STAFF RECOMMENDATION
3614 Richland Avenue
Lot 15, Richland Hall Development
December 20, 2017

Application: New construction—infill and outbuilding
District: Richland-West End Neighborhood Conservation Zoning Overlay
Council District: 24
Map and Parcel Number: 10409008800
Applicant: Chad Gore, Mike Ford Builders
Project Lead: Jenny Warren, jenny.warren@nashville.gov

Description of Project: Application is to construct a new single family infill and an outbuilding.

SITE PLAN

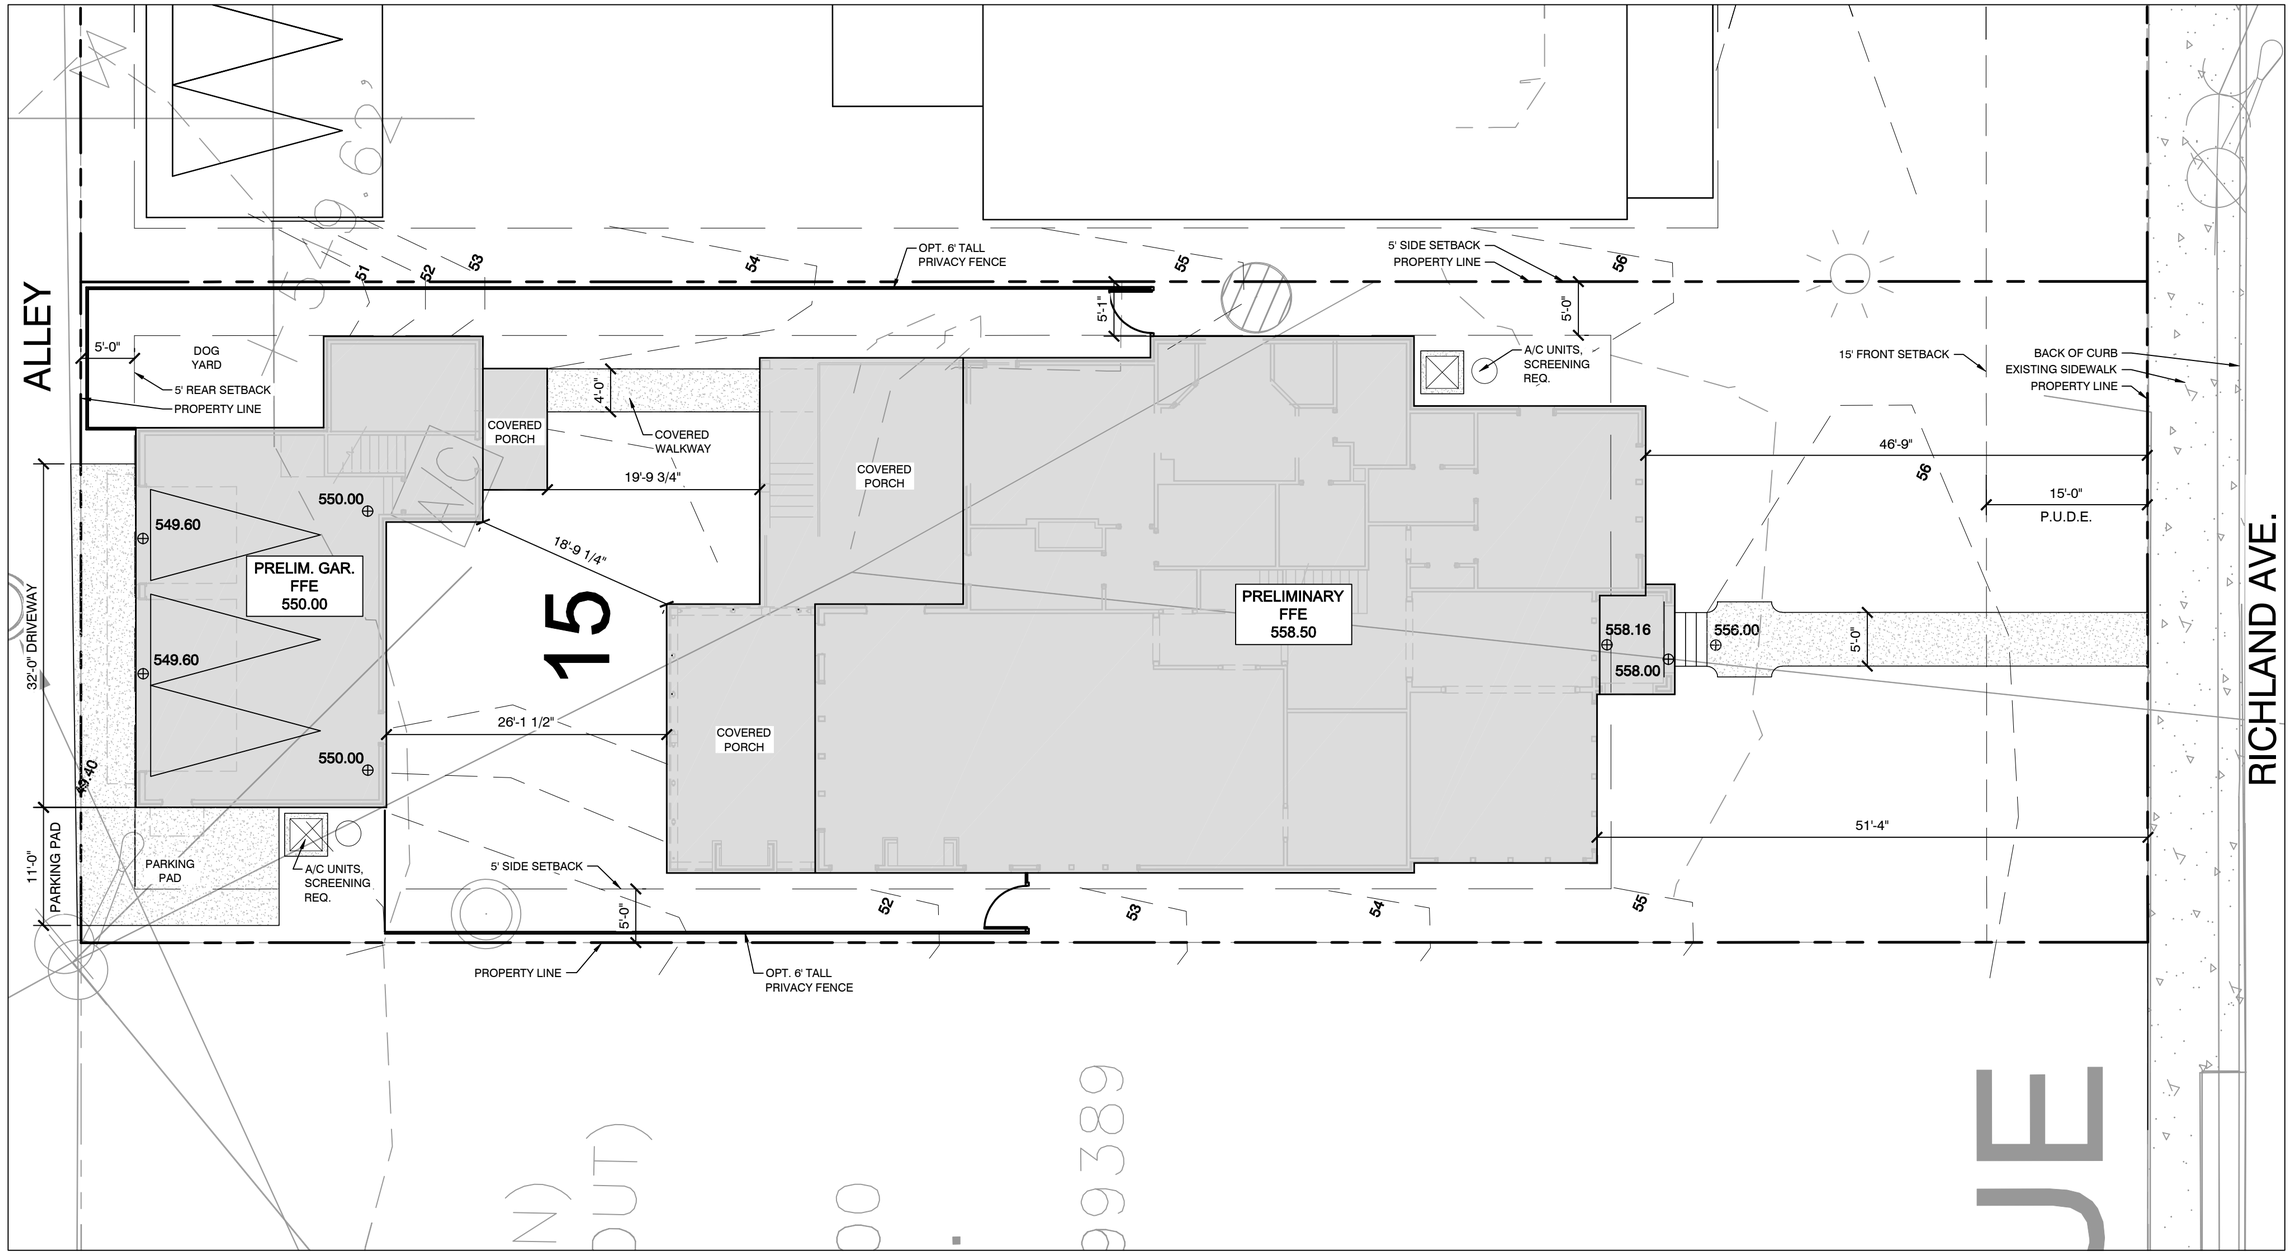
Setback & Rhythm of Spacing: The proposed infill will meet all base zoning setbacks. The proposed front setback for this house is forty-six feet, nine inches (46'9) on the right side and fifty-one feet, four inches (51'4") on the left side. The front setback for this development is intended to line up with the historic house at 3618 Richland Avenue, which is thought to be approximately fifty to fifty-five feet (50'-55'). Staff recommends that the infill be situated so that the portion of the house closest to the front sidewalk lines up with the historic setback found at 3618 Richland, to be verified by MHZC in the field. (The front porch and a small one-story bay would be permitted to extend closer.) Pushing the house further back on the lot may reduce the distance between the back of the house and the outbuilding. Staff recommends that the distance between the two structures be no less than twenty feet (20') as measured from the front wall of the outbuilding.

The infill will meet the five foot (5') side setback requirements on both sides. It will be over fifty-three feet (53') from the rear property line. With the condition that the infill be situated so that the right side of the house lines up with 3618 Richland Avenue, Staff finds that the proposed setbacks to be similar to the immediate historic context and to meet Section II.B.1.c. of the design guidelines.

needs to approve this material as well. The HVAC unit is proposed to be only about fifteen feet (15') from the front wall of the house. Staff requests that this unit be relocated either to the rear, or past the mid-point on either side elevation. With these conditions, Staff finds that the infill meets Section II.B.1.i. of the design guidelines.

1. The finished floor height be consistent with the finished floor heights of neighboring historic houses, to be verified by MHZC staff;
2. The infill be situated so that the portion of the house closest to the front sidewalk lines up with the historic setback found at 3618 Richland, to be verified by MHZC in the field, a small one-story bay would be permitted to extend into this space;

3. The distance between the infill and the outbuilding be no less than twenty feet (20') as measured from the front wall of the outbuilding;
4. Staff approve the stone sample prior to purchase and installation;

5. Staff approve color and texture of the asphalt shingle and metal roof;
6. The HVAC unit be located behind the house, or beyond the midpoint of the house;

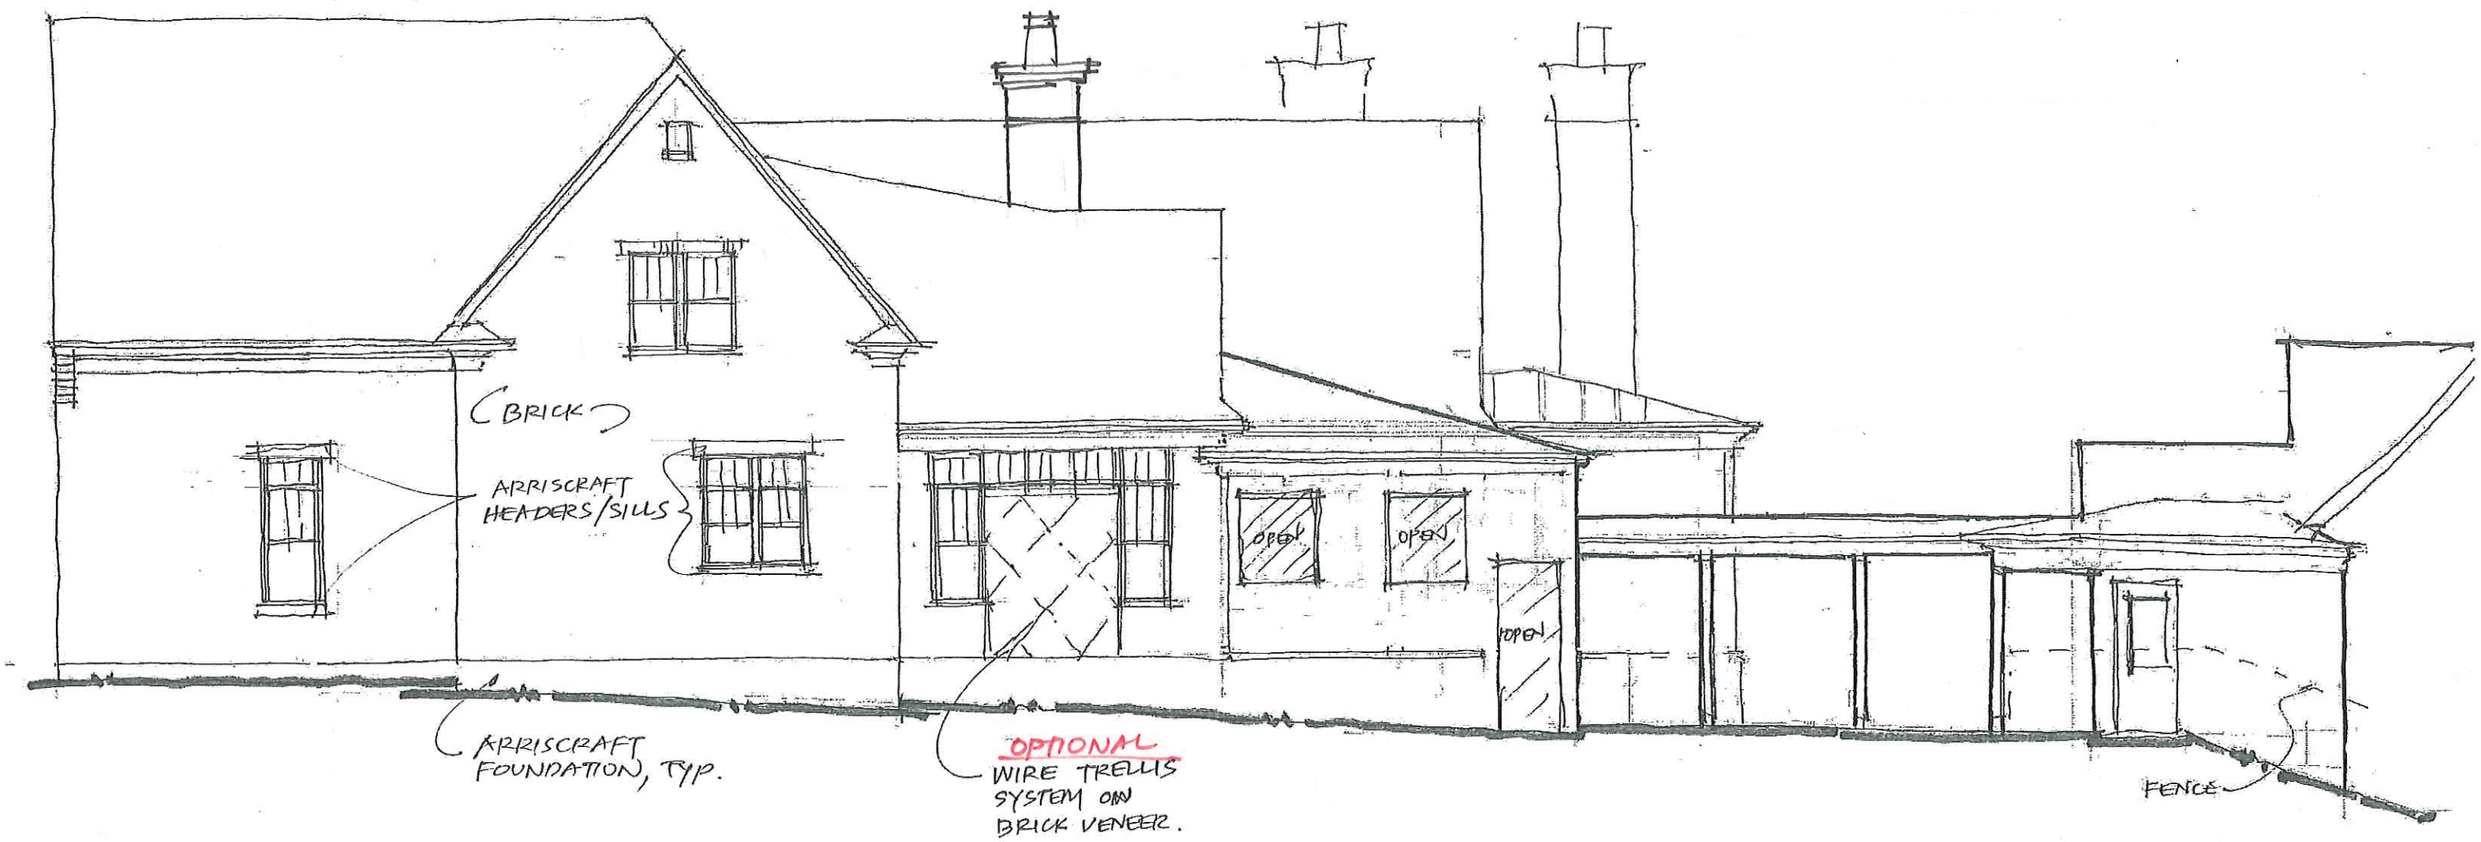
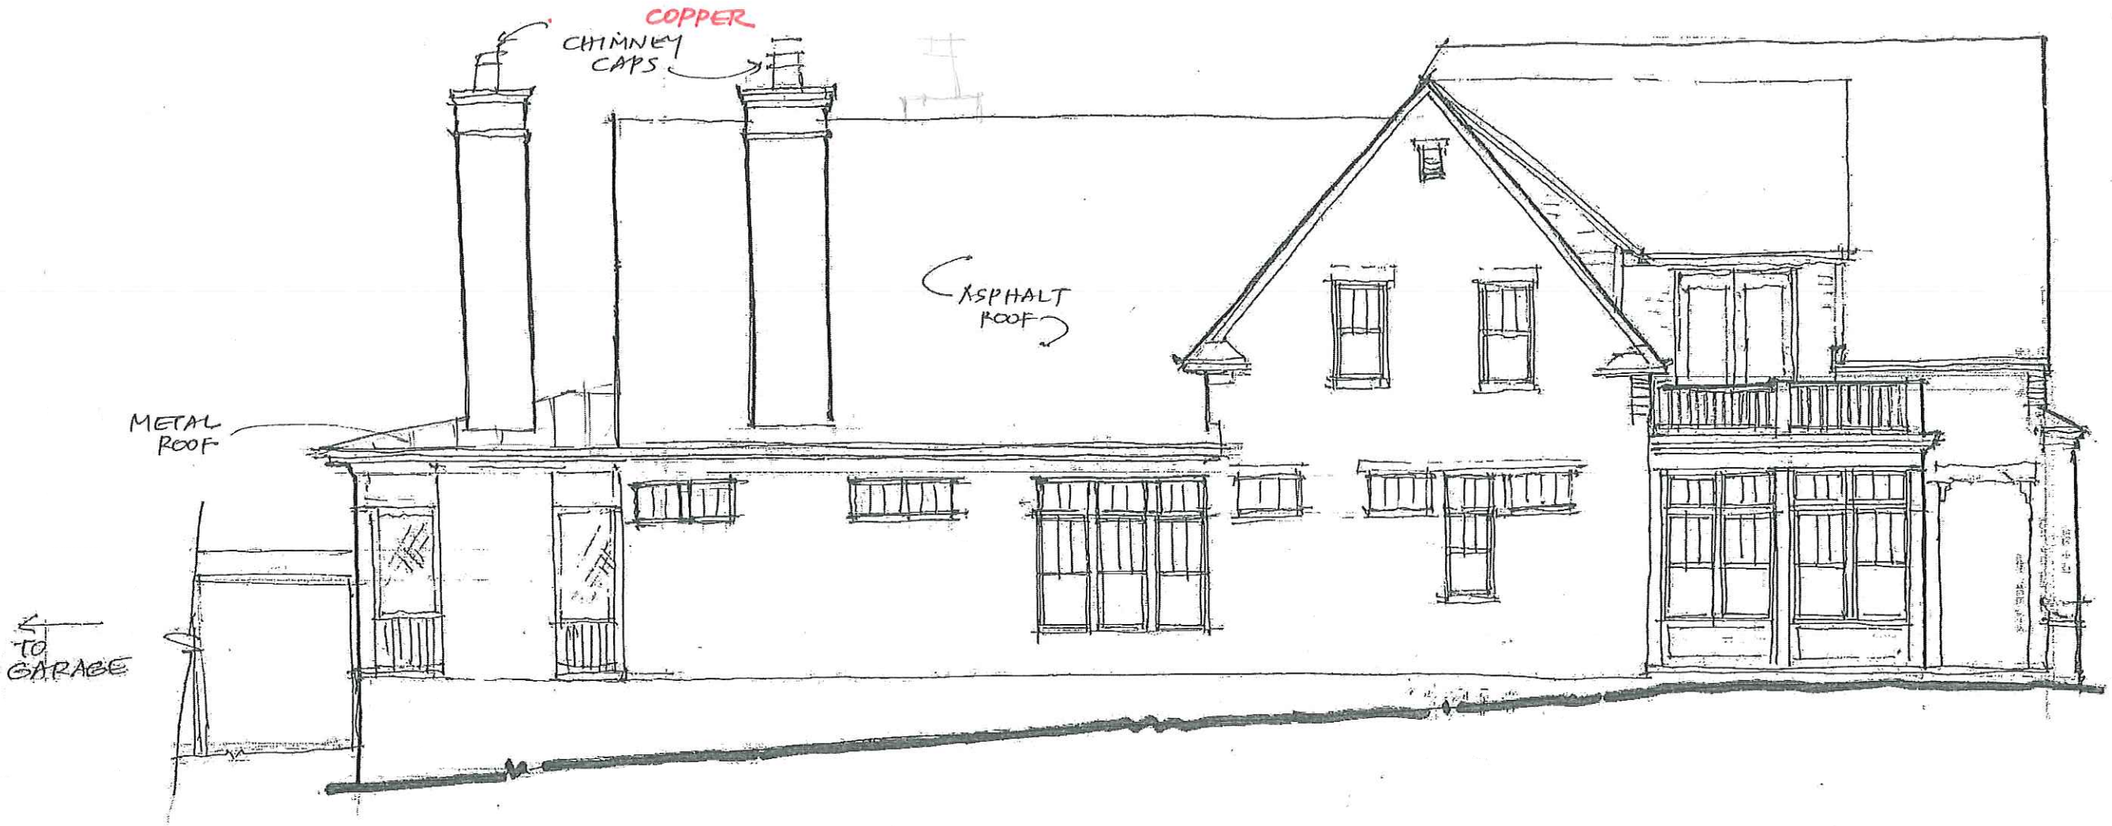
<u>Height & Scale</u>: The proposed infill will be two stories, with a maximum height of thirty-two feet, six inches (32’6”) above the foundation at the front, and approximately thirty-five feet (35’) above grade. The infill will have an eave height of eighteen feet (18’) above the grade at the front. The foundation height will vary due to grade, but will be approximately twenty-four inches (24”) at the front. Staff finds that the proposed height is similar to the heights of historic houses in the immediate vicinity, which range from thirty to forty-four feet (30’ – 44’). It is also in keeping with what has been approved in the past for the infill houses in this development.

Roof form: The infill's primary roof form is a cross-gabled roof with a steep 14/12 pitch on the front, side and rear elevations. A shed dormer on the front elevation is inset two feet (2') from the main wall and has a slope of 6/12.

Proportion and Rhythm of Openings**:** The proposed windows on the infill are generally twice as tall as they are wide, thereby meeting the historic proportion of window openings. There are no large expanses of wall space without a window or door opening All window groupings have a four to six inch (4"-6") mullion in between the individual window openings. On the side elevations, there are several windows that are long and narrow, Staff finds them to be appropriate, however because the majority of them are over forty-five feet (45') back from the front of the house and because they are used sparingly. Staff finds that the infill's proportion and rhythm of openings meet Section II.B.1.g. of the design guidelines.
